**AGENDA
CITY OF STURGEON BAY
AESTHETIC DESIGN & SITE PLAN REVIEW BOARD**

Monday, March 14, 2022

To: Aesthetic Design and Site Plan Review Board
From: Christopher Sullivan-Robinson
Date: March 9, 2022
Subject: Project Review – 911 Green Bay Rd

EXTERIOR ELEVATIONS

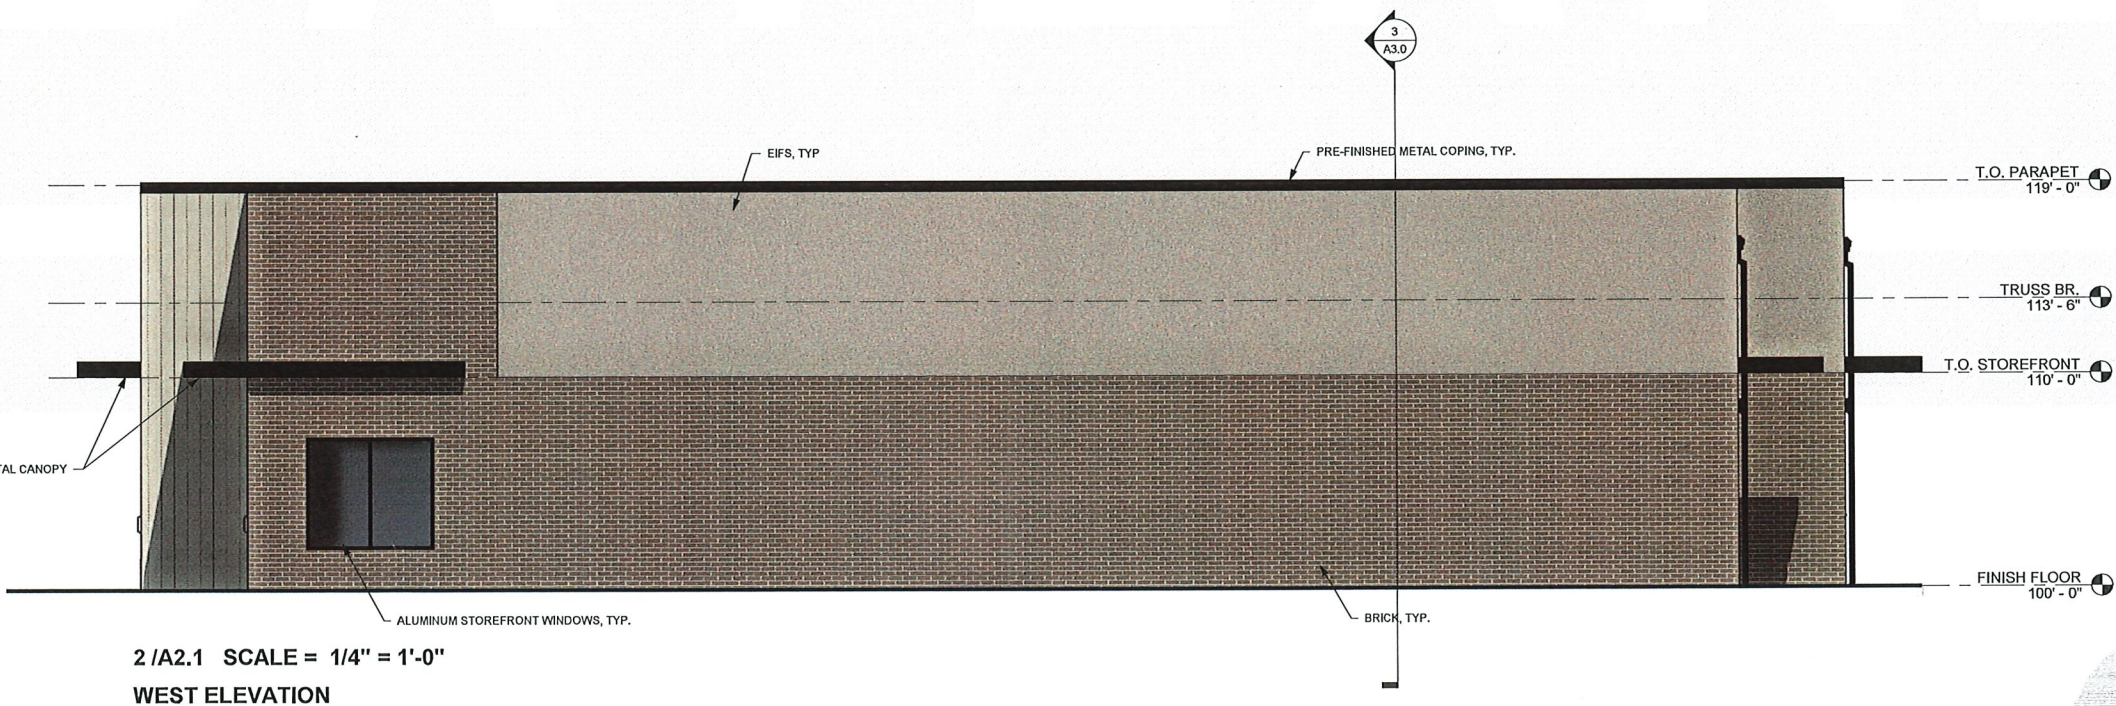
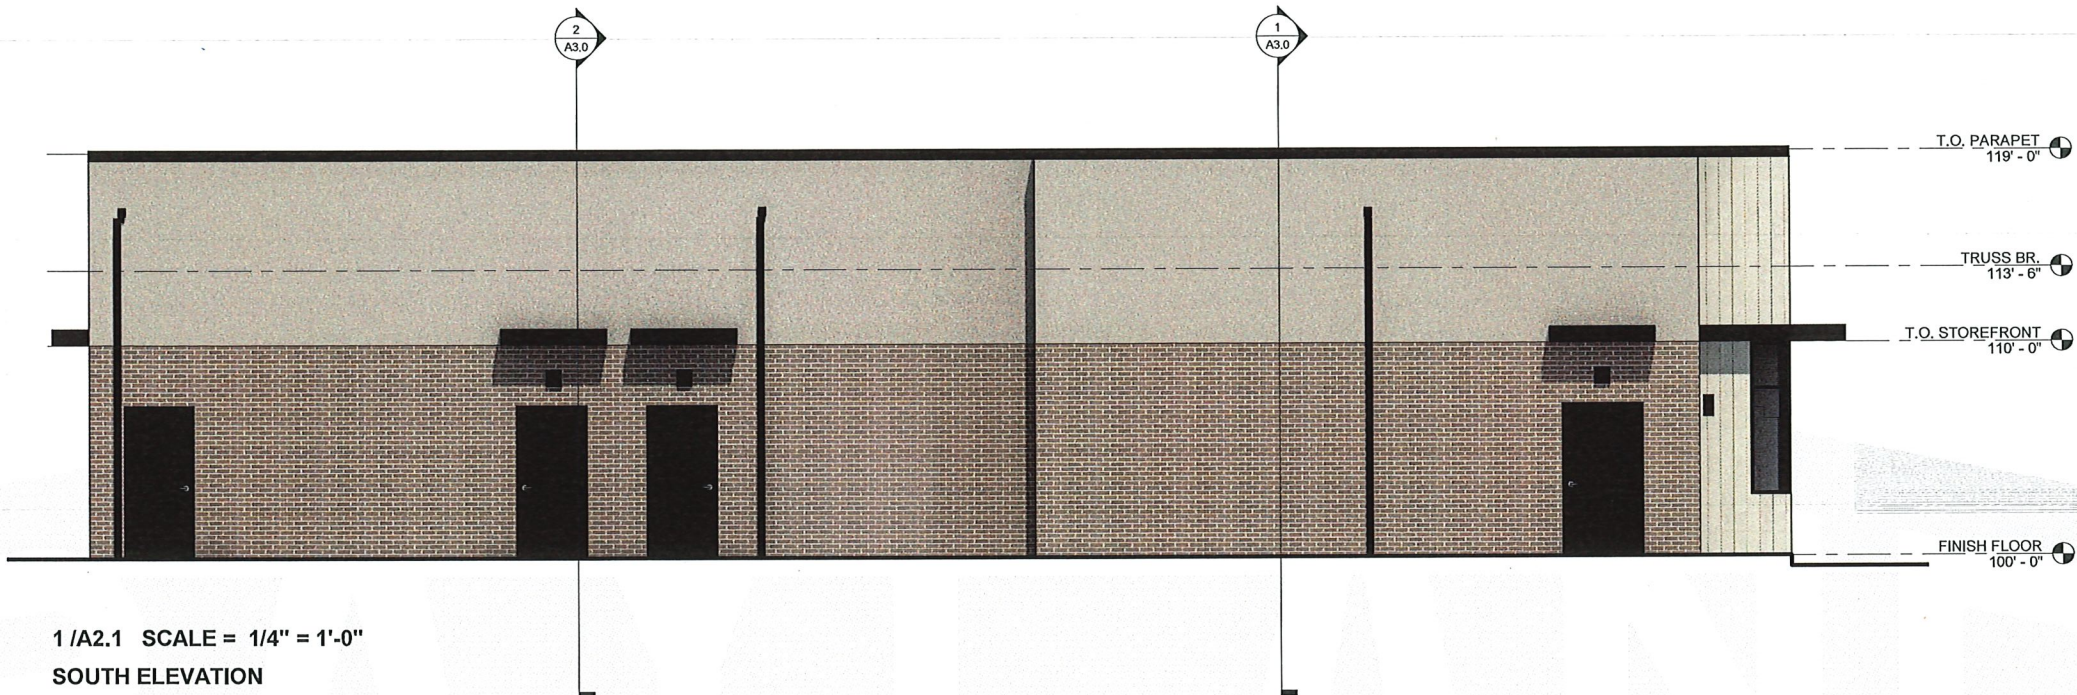
The proposed building utilizes a combination of brick, vertical wood cladding and an insulated finishing system. There are no conflicts with compatibility with surrounding properties.

There doesn't appear to be any conflicts with the design criteria since the building utilizes a mix of materials, canopies, and entryways that break up the façade.

There are majority of the windows are on the north and east side of the building. I don't believe the windows are tinted; however, this will need to be verified with the applicant.
